Board of Adjustments Called Special Session

Wednesday, December 29, 2021 at 6:30 PM

Re: Bank of America – Manor Commons
SWC Hwy 290 & FM 973
Job No: 20.0003779.000

Alternative Methods of Compliance (AMOC)

1
A00.60
SITE PLAN
3/32" = 1'-0"

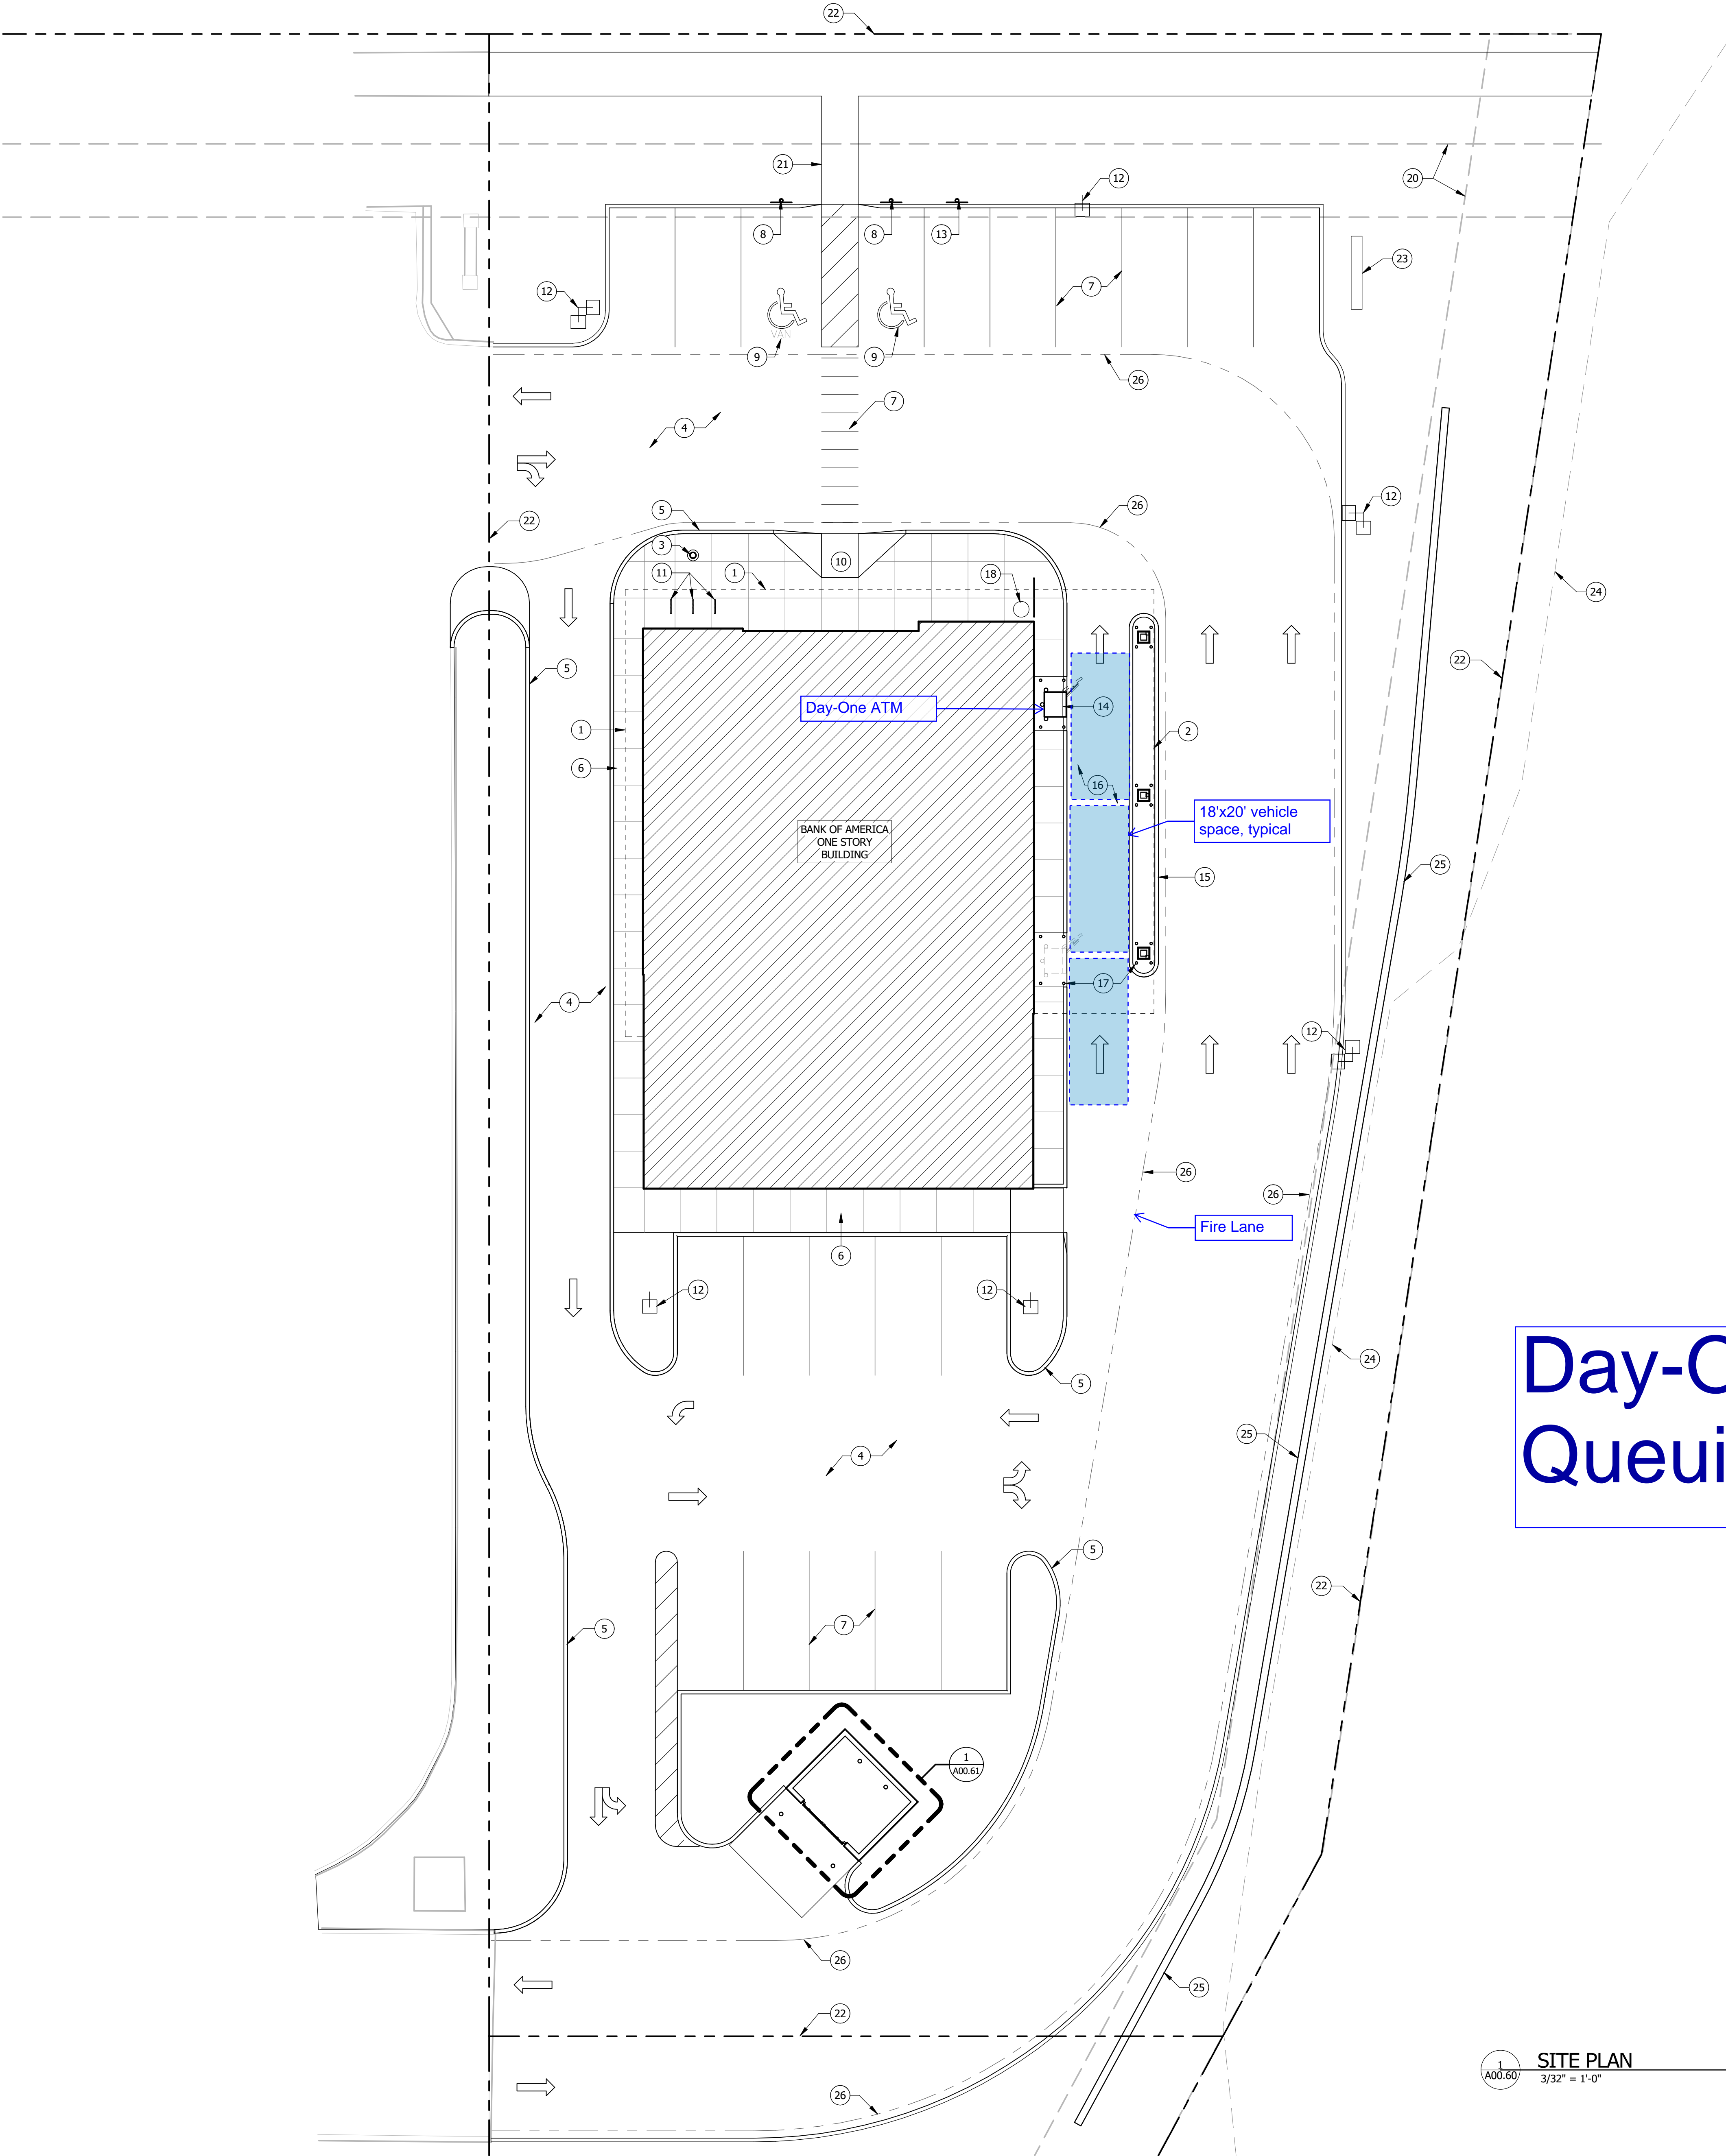
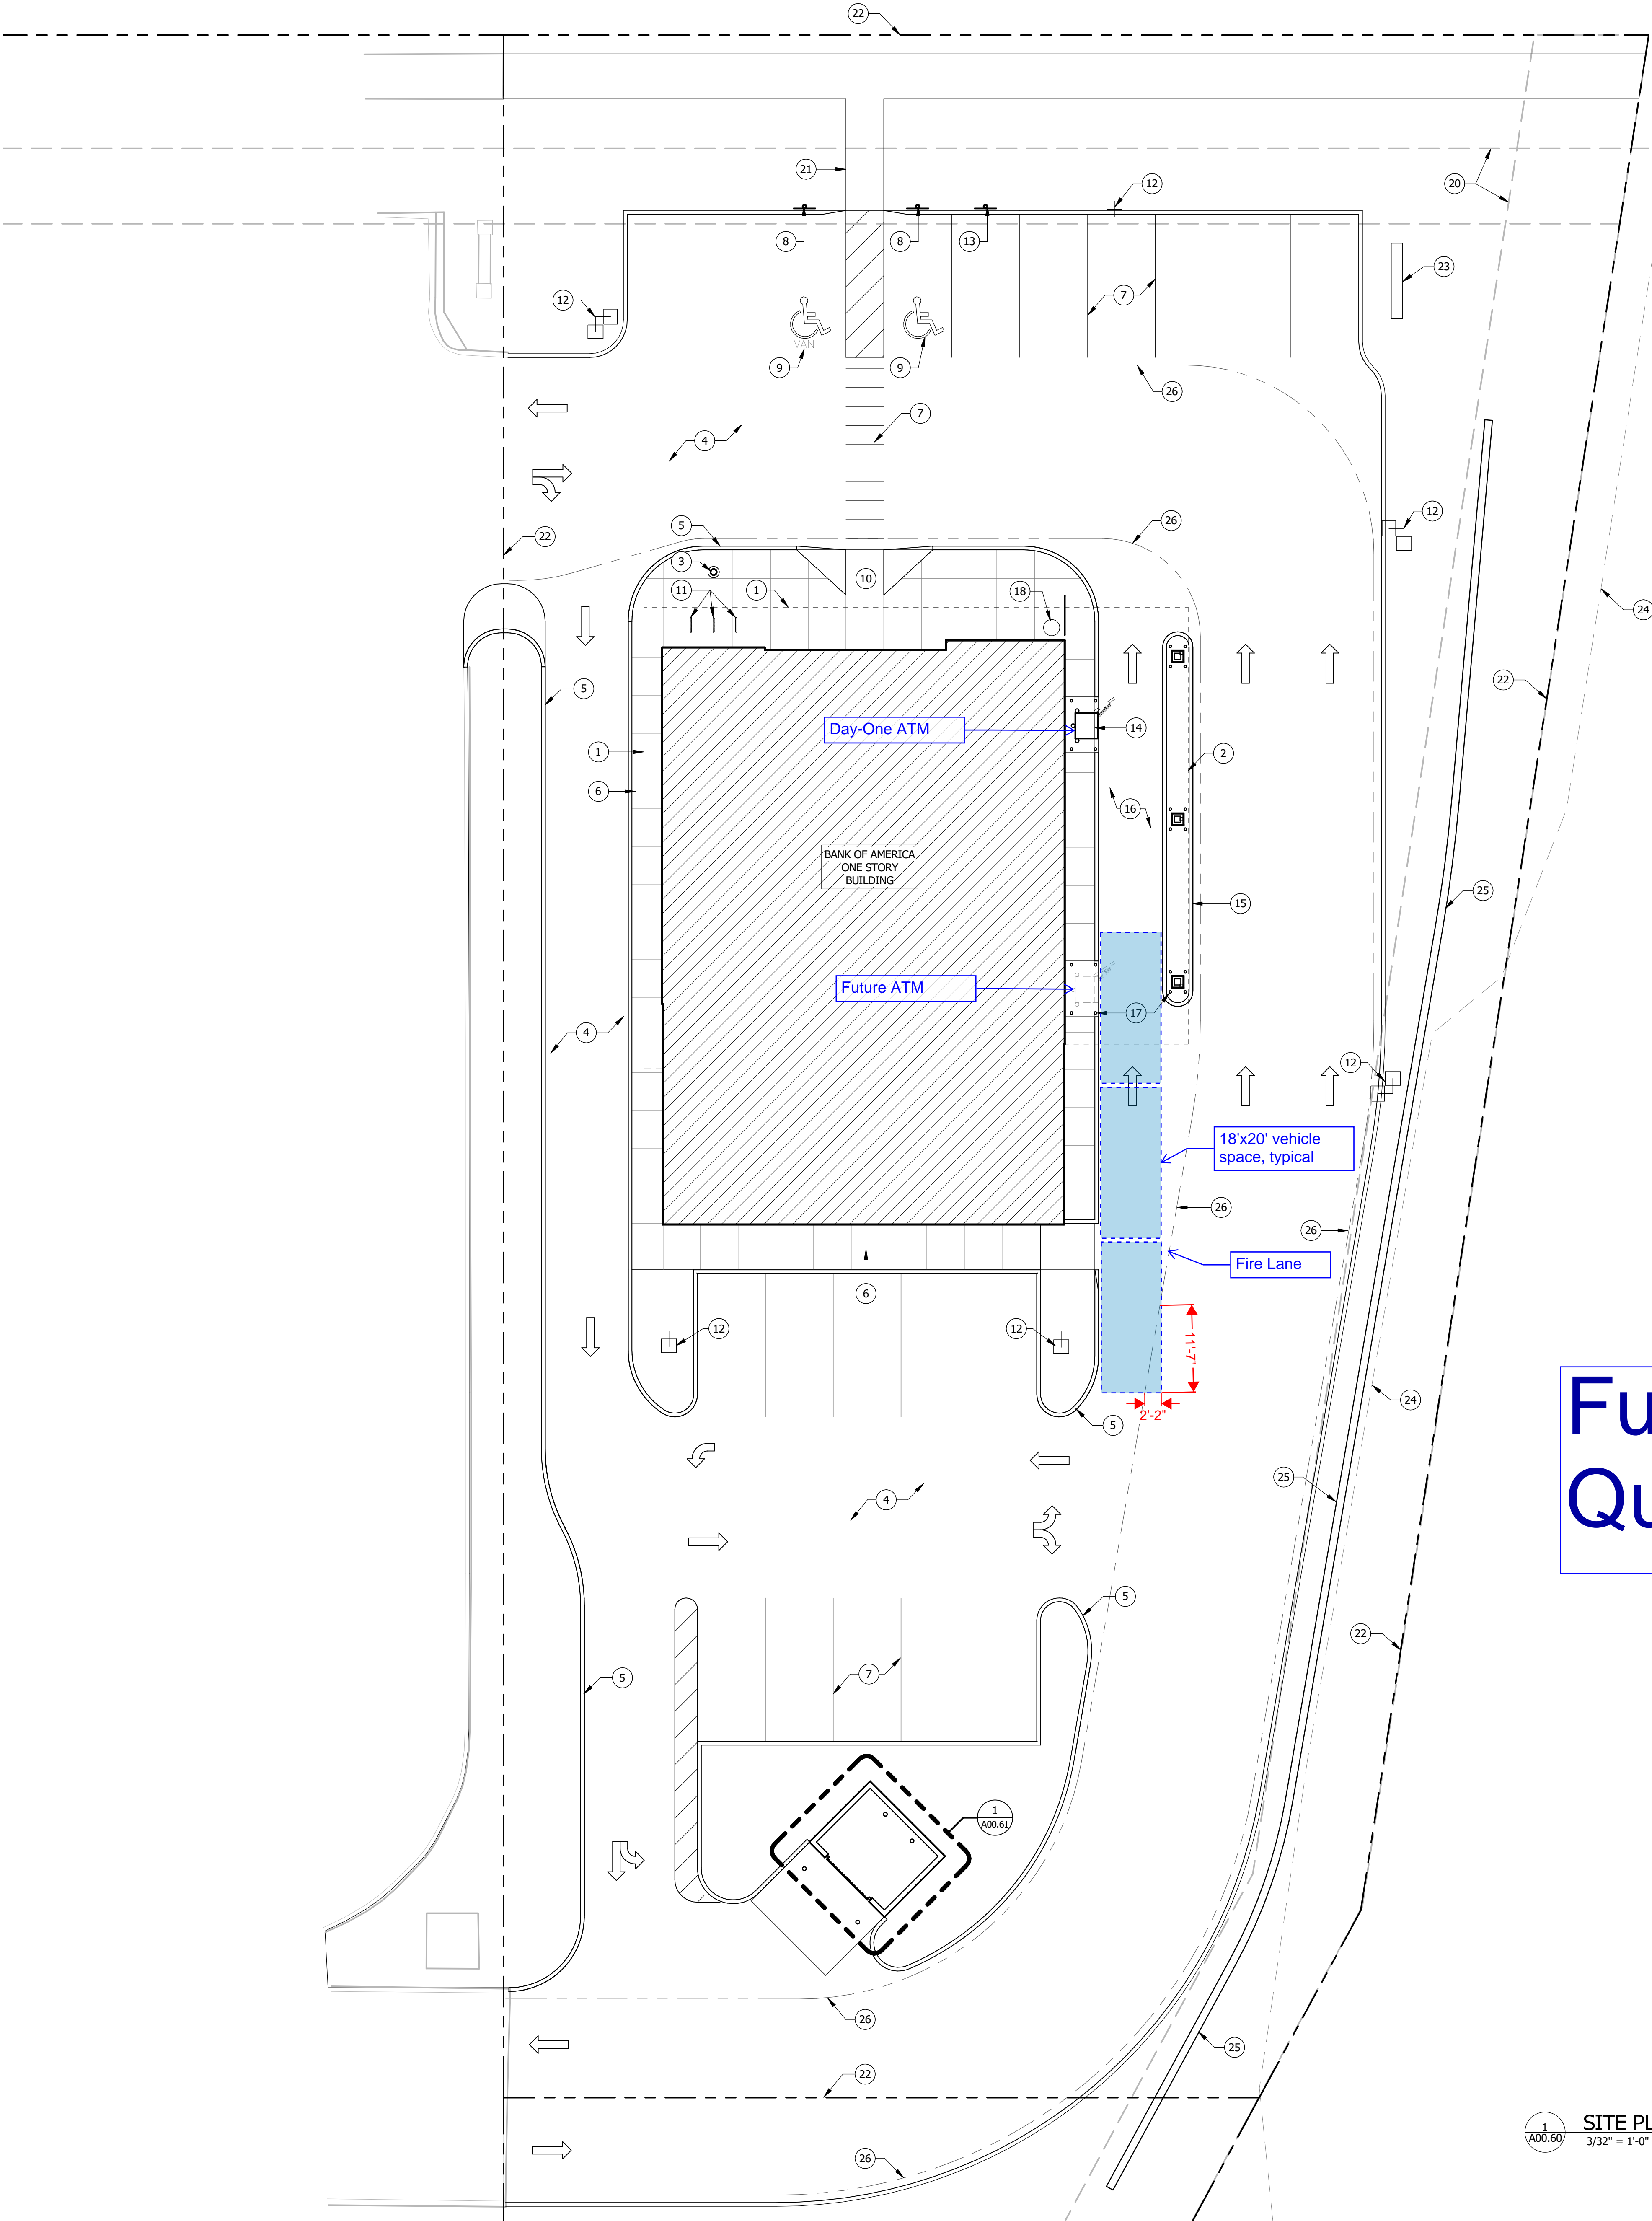
This letter is to ask for your consideration in granting a Planning & Zoning variance, specifically a variance regarding the Manor, Texas Code of Ordinances 09/10/21 Supplement 4, Section 15.02.005 – Queuing requirements. This variance request is only for the proposed future drive-up ATM location. The Day-One ATM location – which will be installed as part of the Bank's primary scope of work and will be available to the public once the Bank's construction is complete – meets the City's queuing requirements and does not require a variance. Diagrams have been uploaded to illustrate the 2 separate ATMs and their queuing.

We request this variance due to the nature of the property tapering to approximately 100', the need for a retaining wall along the east property line and the necessity of providing fire department access around the building. Because of these constraints, our site does not leave sufficient room for the City's minimum 3-car queuing line at the proposed future drive-up ATM without encroaching into the 26-foot wide Fire Lane. We request a variance to allow for a 2-car queuing line at the proposed future drive-up ATM to avoid encroachment into the Fire Lane or allow a third car to encroach into the Fire Lane by 2'-6" for approximately half a car length. If the variance is not granted, the Bank will have its drive-up ATM capacity limited to one ATM. The Bank prefers to have the option to add a second ATM in the future as part of their overall site development strategy. This variance request applies only to the future ATM - the site plan as submitted meets the City's requirement for 3 car queuing at the "day-one" ATM to be installed under the current scope of work.
